Product Change Notification (PCN)

PCN Number	501666	Date Issued	November 07, 2016
Reason for Change	Obsolete		
Change Type Description	This is to inform you that the part(s) referenced in this notice will be made obsolete due to low demand. Please contact your Molex Sales Engineer for additional questions concerning possible replacement part(s).		
Planned Implementation Date	September 12, 2017		
Last Time Buy Date for Obsolete Parts	June 12, 2017		
Last Time Ship Date for Obsolete Parts	September 12, 2017

Overview

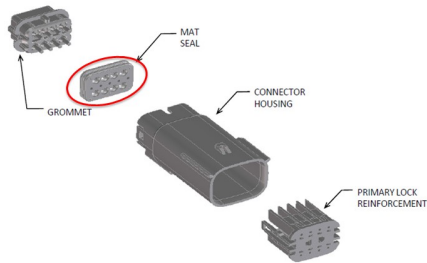
- For continuous improvement, Molex will be upgrading the Mat Seal within the MX150 2x4 Blade for seal tear reduction
- Product Impact
 - Mat seal hole geometry and hole location optimization
 - Seal color change from rust red to royal blue
 - No change to hole diameter
 - Material will remain the same inherently lubricated silicone
- Part Number Impact
 - 33482-08xx will become obsolete, replaced by 33482-48xx
- PPAP and samples available upon request
